Department of Transportation

MEMORANDUM

SUBJECT: ZC Case No. 09-03F – Skyland Town Center

Figure 1 | Site Plan

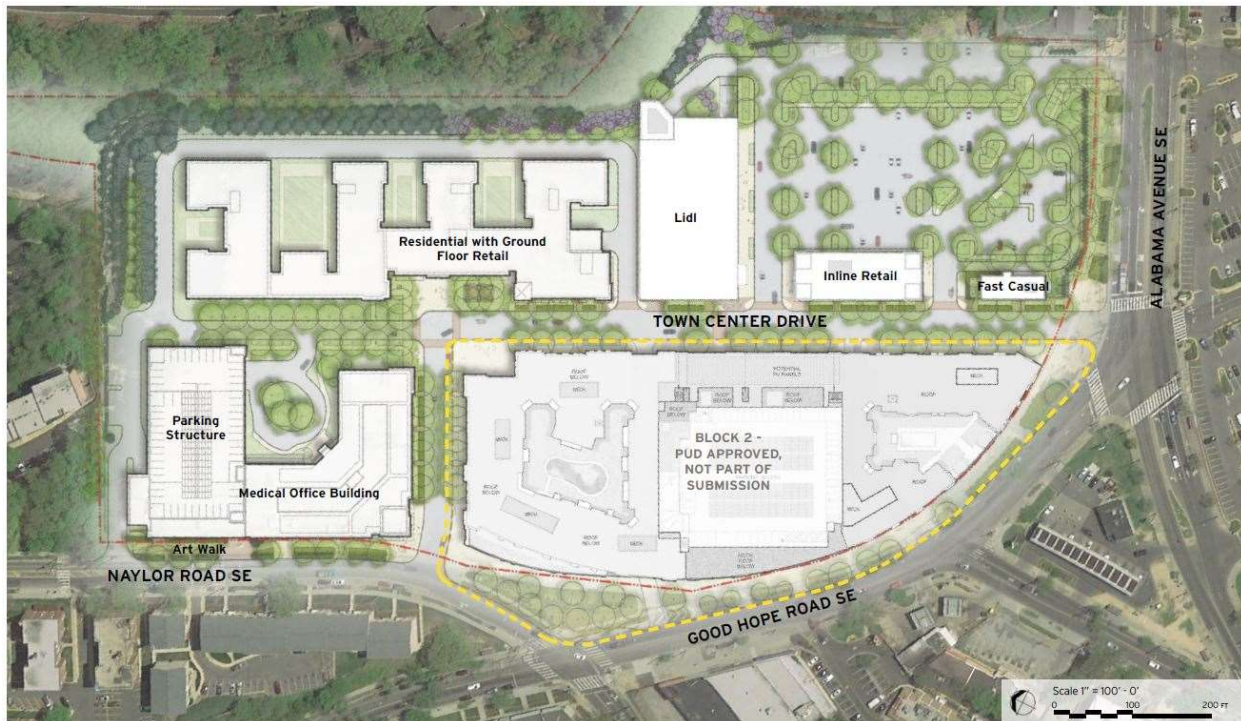
- The lack of connections to adjacent neighborhoods via 28th Street SE and Akron Place are missed opportunities. More connectivity would allow for better dispersal of traffic, improved circulation, and shorter travel routes for pedestrians and cyclists. The Applicant should explore the possibility of making these connections;

- There appears to be missing curb ramps along the internal private streets. The Applicant should ensure that the internal pedestrian network is complete and ADA accessible; and

DDOT notes that the site does not connect to adjacent neighborhoods with either vehicular or pedestrian facilities. This is a missed opportunity for improved connectivity that will help disperse traffic and shorten walking distances for residents of the surrounding neighborhoods seeking to access the site. DDOT requests the Applicant explore constructing a vehicular access point with sidewalk to the existing 28th Street SE stub and a new pedestrian connection to the existing sidewalk on the south side of Akron Place SE.

Figure 2 | Loading Circulation Plan

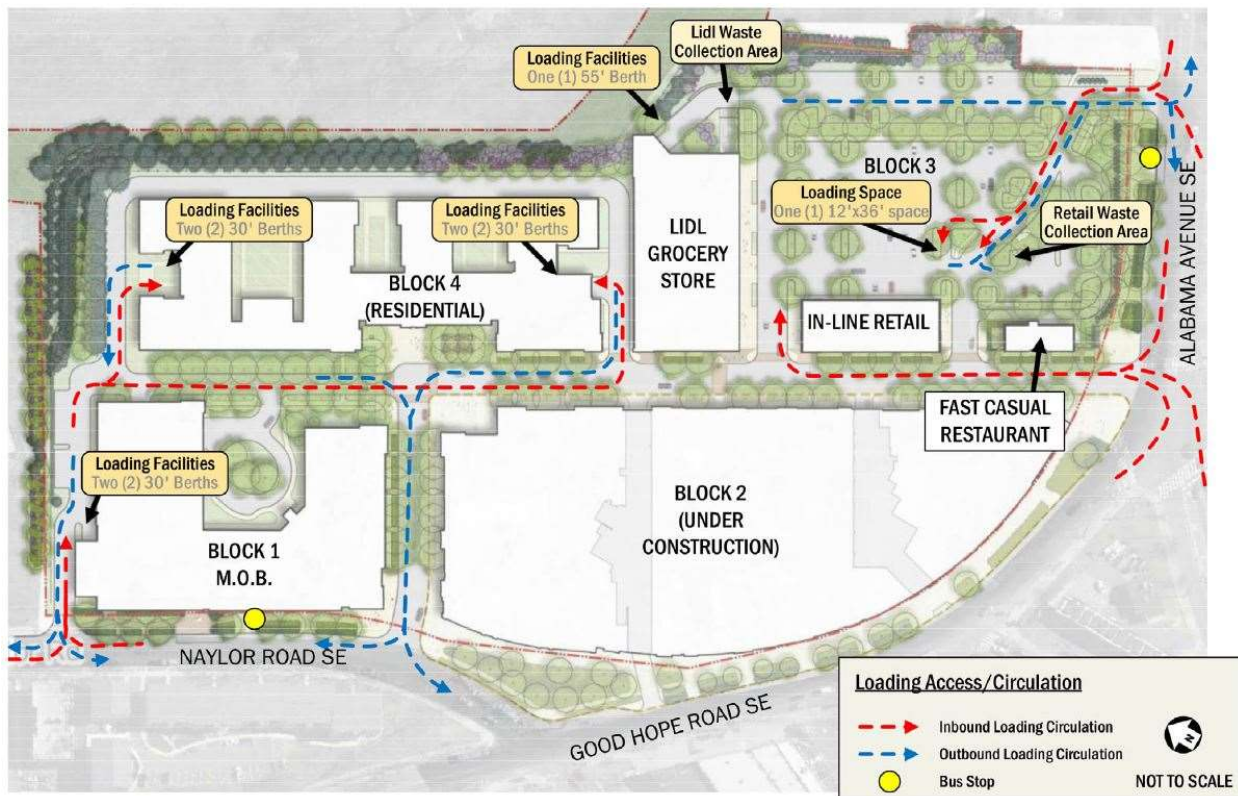
Blocks 1, 3, and 4 have been designed so that all loading activities, including delivery trucks, moving trucks, and trash pick-up, take place on private property with only head-in/head-out movements through DDOT public space. The locations of loading facilities and anticipated truck circulation are shown in Figure 2 below. DDOT finds this loading scheme acceptable. The Applicant has proposed a Loading Management Plan in the June 8, 2020 CTR Study to address the loading relief requested for Block 3. DDOT finds this plan acceptable and should be included as a condition of approval.
